**CALIFORNIA COASTAL COMMISSION**

## ADDENDUM

SUBJECT: **ADDENDUM TO ITEM TH14C, DE NOVO APPLICATION NO. A-5-VEN-20-0039 FOR THE COMMISSION MEETING OF THURSDAY, FEBRUARY 11, 2021.**

### Exhibit 3– Revised Project Plans (dated February 8, 2021)

**G050**  
02.08.2021

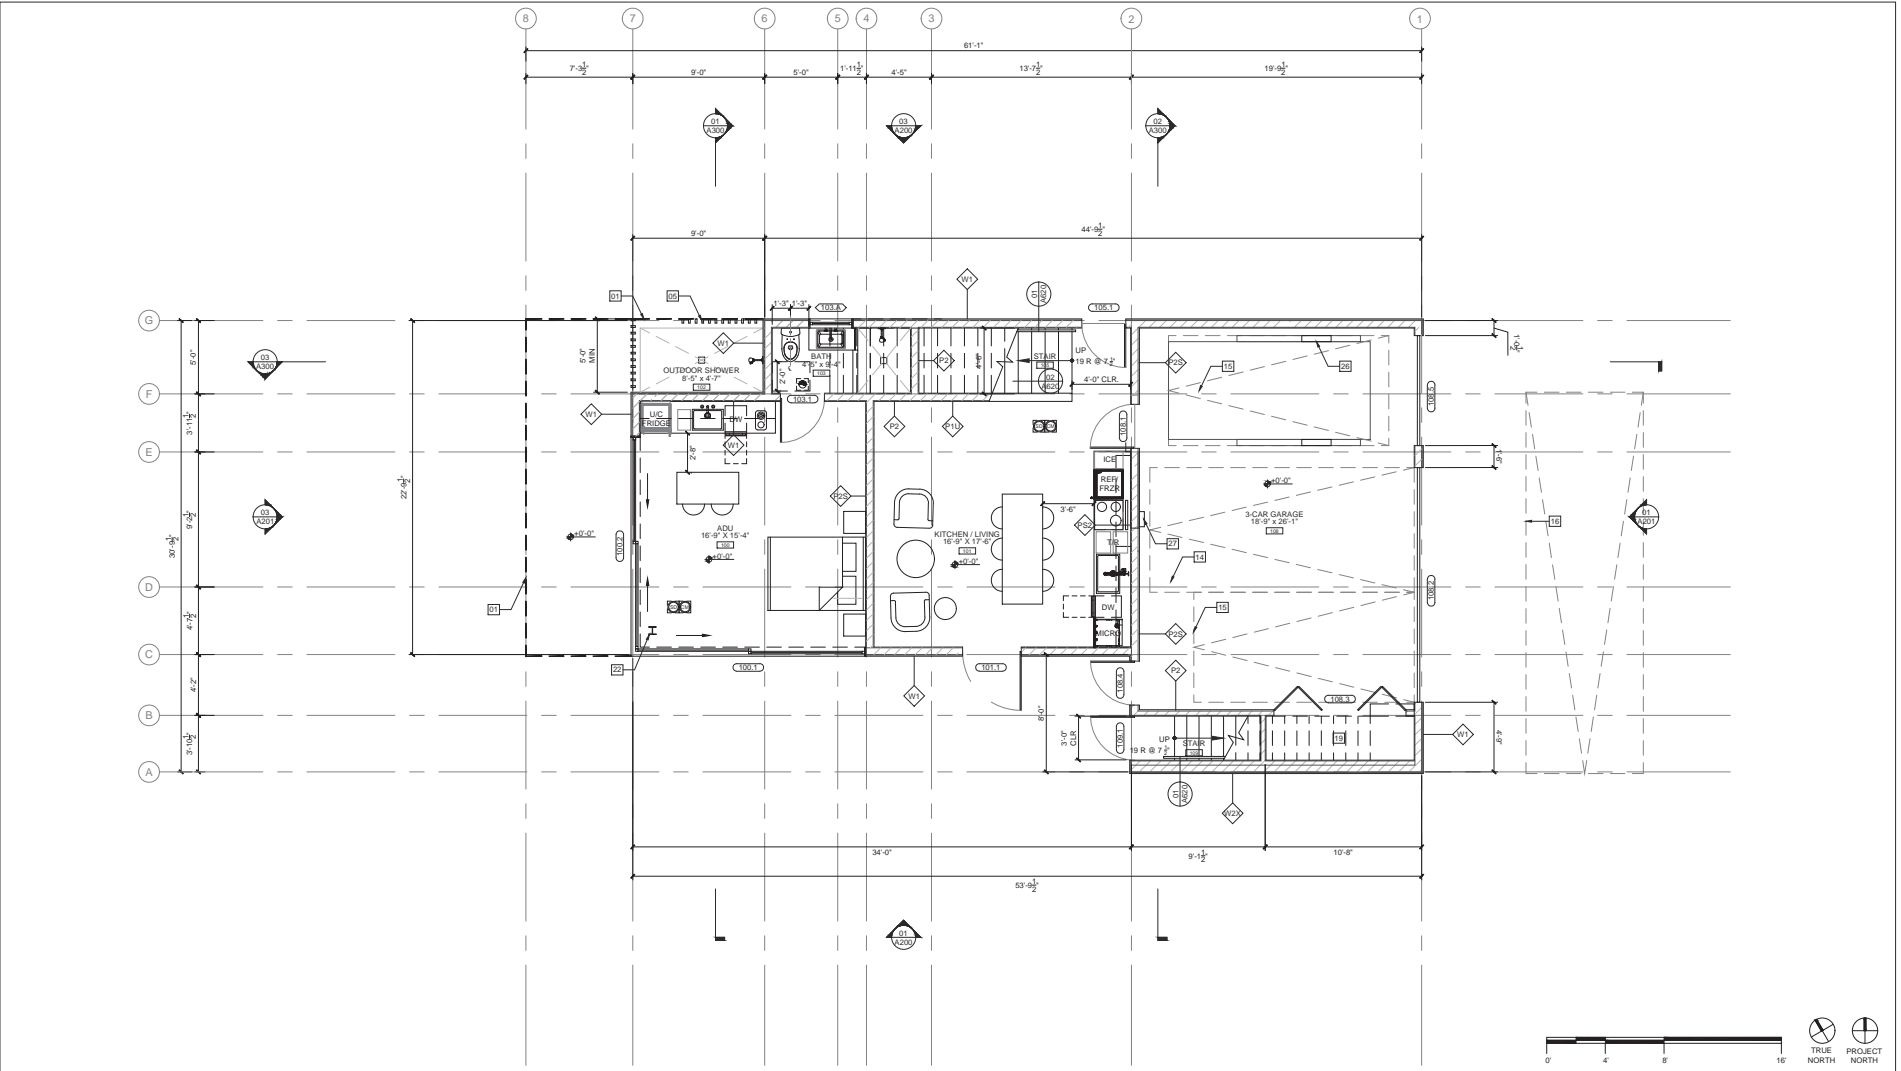
**(5) The project plans show discrepancies in estimated areas and setback lengths, as well as mis-labeled or missing amenities throughout the units** The applicants have submitted plans (dated February 8, 2021) revised to correct inaccuracies and more clearly show the location of the proposed bathrooms and dining areas throughout the units. It is important to note that these revised plans have not altered any of the area estimations proposed with the plans dated January 19, 2021. The plans dated February 8, 2021 shall replace the plans included in Exhibit 3 of the staff report and are attached to this addendum. Commission staff

<b>Proposed</b>	<b>Area (sq. ft.)</b>	<b>Existing</b>	<b>Area (sq. ft.)</b>
Unit 1 (excluding decks)	718	Unit 1	768
Unit 2 (excluding decks)	730	Unit 2	1,200
ADU	310	N/A	N/A
Total habitable area	1,758	Total habitable area	1,968
Pool	738	N/A	N/A
Landscaped yard	709	Landscaped yard	Unknown
Garage (attached)	523	Garage (detached)	627
Parking on-site	5 spaces	Parking on-site	3 spaces
